Addendum D2

re: **Fort Wayne Community Schools
Renovations of Franke Park
111031.01**

issue date: **November 14, 2025**

Addendum: 2
Date: 11/14/2025
Project: Franke Park Elementary School
Renovation
Comm #: 23475

E3.1

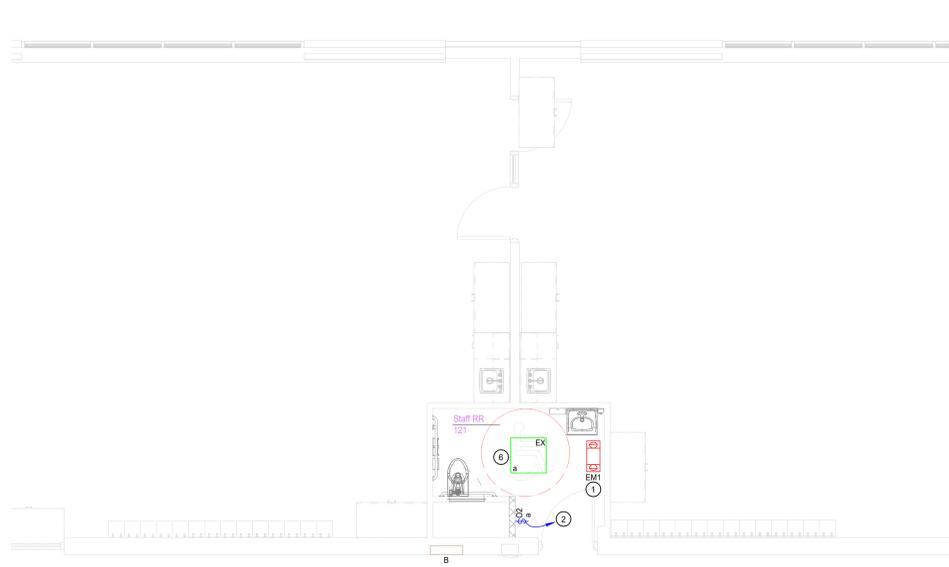
- A.** Addition of callout bubbles to electrical sheet for clarification of associated details. Refer to revise sheet E2.1, E2.2, E3.1, E3.2 and E5.1 for additional information.
